## > Customer Product Information (CPI)

<b>Product group:</b>	<b>SEMIPACK</b>	<b>Rev.:</b>	<b>1</b>
<b>No.:</b>	<b>PN20-096</b>	<b>Minor change of DBC layout for SEMIPACK 2 modules (time schedule updated)</b>	<b>02 Nov 2020</b>

**Subject of change:** DBC layout

**Current DBC layout (as example SKKT 162)**

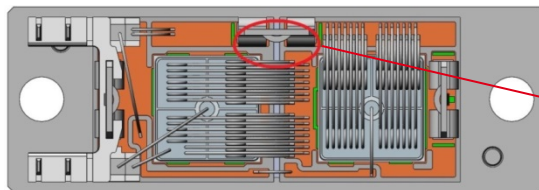
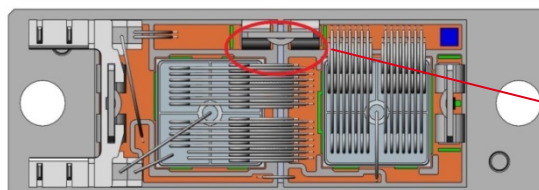
**Description of change:** Changes in the marked area to achieve constant larger distance between the terminal feet and the adjacent copper area. The change does not affect the current path and has no impact on electrical and mechanical properties of the modules.
